**REVISIONS TO THE RED HILL GROUNDWATER PROTECTION PLAN**

**Date:** December 2009  
**Document Title:** Red Hill Bulk Fuel Storage Facility Final Groundwater Protection Plan, Pearl Harbor, Hawaii of January 2008

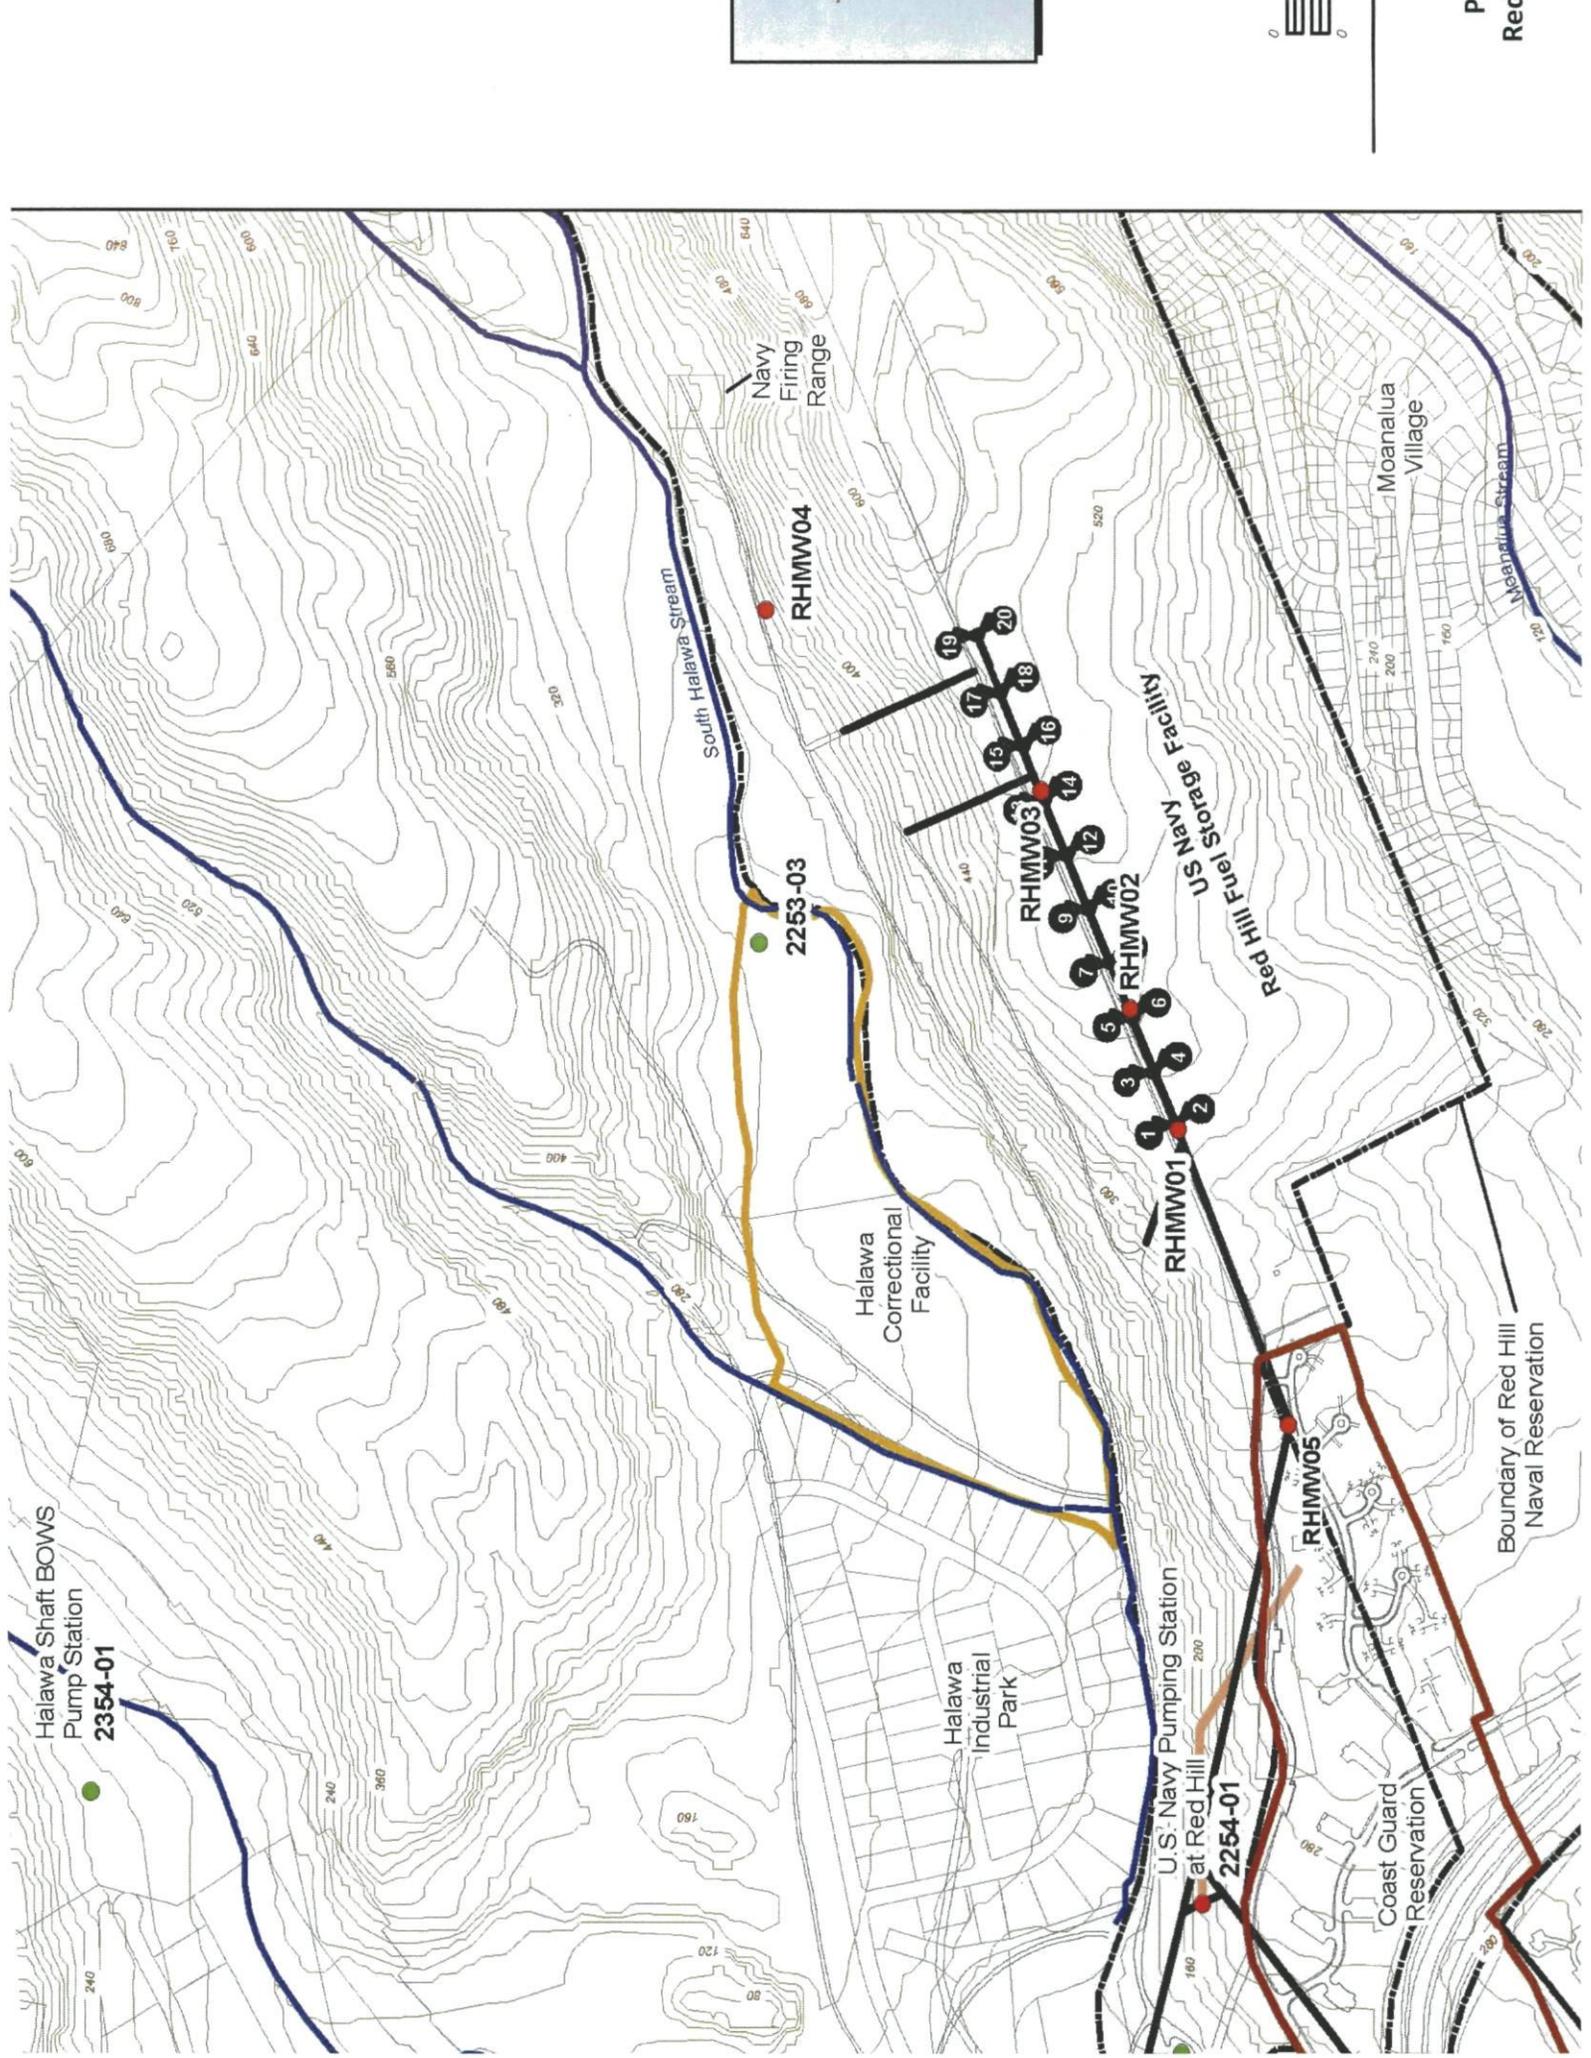
2.	ES-3	Executive Summary	Paragraph 2, Line 2 – Revise “The U.S. Navy will provide the results of the API inspections and maintenance reports to the HDOH with the quarterly reports associated with groundwater and soil vapor monitoring.” to “The U.S. Navy will provide the API inspection and maintenance reports to the HDOH upon completion.” Added the location of RHMW05	The API inspection and maintenance reports will be submitted to the HDOH under separate cover from the quarterly groundwater monitoring reports upon request
